AMENDMENT OF SOLICITATION/MODIFICATION OF CONTRACT				1. CONTRACT ID CODE	PAGE OF PAGES 1 110
2. AMENDMENT/MODIFICATION NO. 0003		3. EFFECTIVE DATE 27 OCT 2020	4. REQUISITION/PURCHASE REQ. NO.	5. PROJECT NO. (If applicable)	
6. ISSUED BY CODE U.S Army Corps of Engineers, Los Angeles Dist CESPL-CT-E, East Region Branch 915 Wilshire Blvd. Los Angeles, CA 90017		7. ADMINISTERED BY (If other than Item 6) SEE ITEM 6	8. NAME AND ADDRESS OF CONTRACTOR (No., street, county, State and ZIP Code)		
CODE		FACILITY CODE	(X)	9A. AMENDMENT OF SOLICITATION NO. W912PL-21-B-0002	
			<input type="checkbox"/>	9B. DATED (SEE ITEM 11) 18 September 2020	
			<input type="checkbox"/>	10A. MODIFICATION OF CONTRACT/ORDER NO.	
			<input type="checkbox"/>	10B. DATED (SEE ITEM 13)

FY18 GROUND TRANSPORT EQUIPMENT FACILITY, FORT HUACHUCA, AZ

GROUND TRANSPORTATION EQUIPMENT BUILDING (GTBE) FORT HUACHUCA
AMENDMENT 0003 SUMMARY OF CHANGES

SHEET ID
T-502

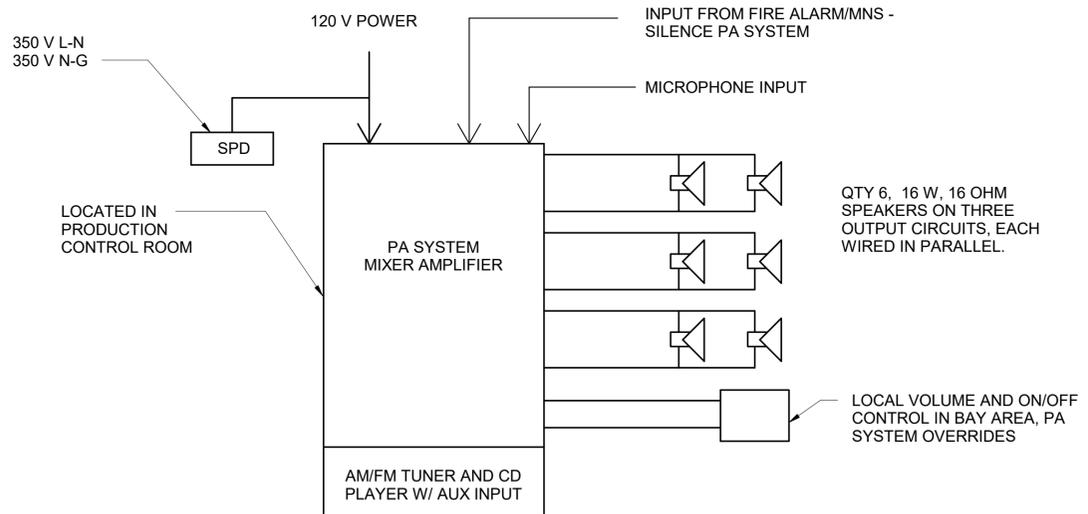
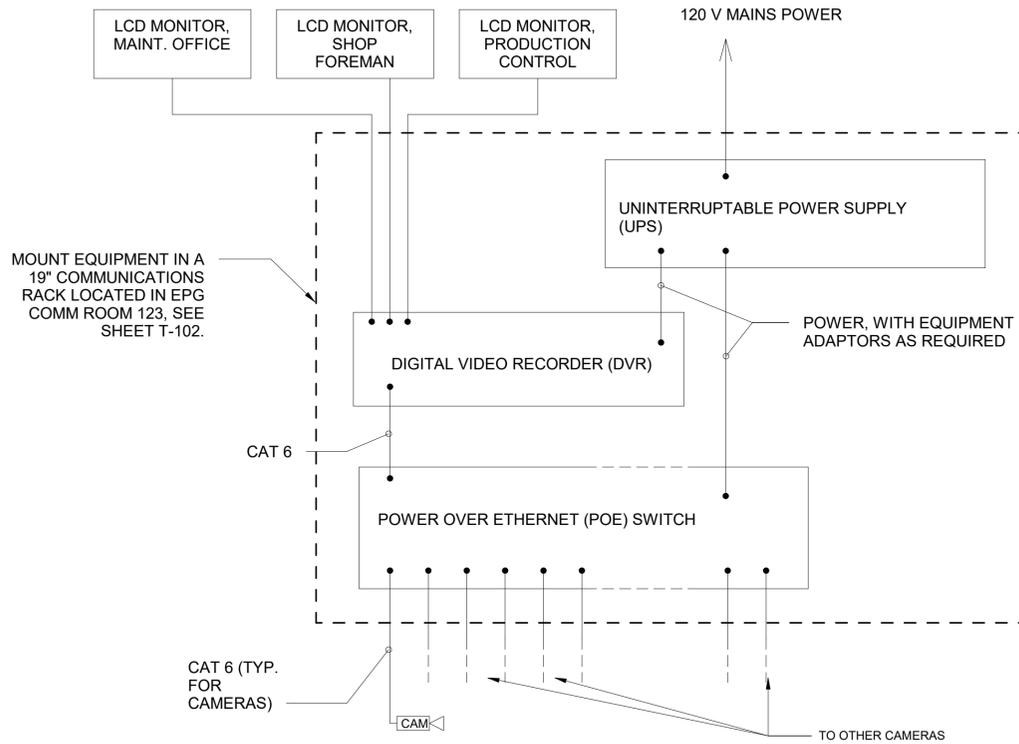
10. Revise Drawing FA-601 adding Note 6 on Fire Alarm Panel requirement (Monaco).
11. Revise a series of Electrical drawings; E-001; EP-102; EG-102; E-401; E-402; E-504; 101; T-102; T-103; T-501; T-502; T-601.

MARK	DESCRIPTION	DATE
4	CLARIFY CCTV SCOPE	07 OCT 2020

- SEE SPEC SECTIONS FOR ADDITIONAL DETAILS
- TYPICALLY, CCTV EQUIPMENT IS GFGI. CONTRACTOR SHALL INSTALL J-BOXES AND CONDUIT SYSTEMS WITH PULL STRINGS CONNECTING EQUIPMENT LOCATIONS FOR CCTV EQUIPMENT, FOR USER TO INSTALL CAMERAS, CABLING AND EQUIPMENT (CAMERAS, DVR, POE SWITCH, UPS, AND MONITORS). CONTRACTOR SHALL FURNISH AND INSTALL RACK FOR CCTV EQUIPMENT. COORDINATE WITH PLANS FOR LOCATIONS OF EQUIPMENT AND CCTV CAMERA LOCATIONS.
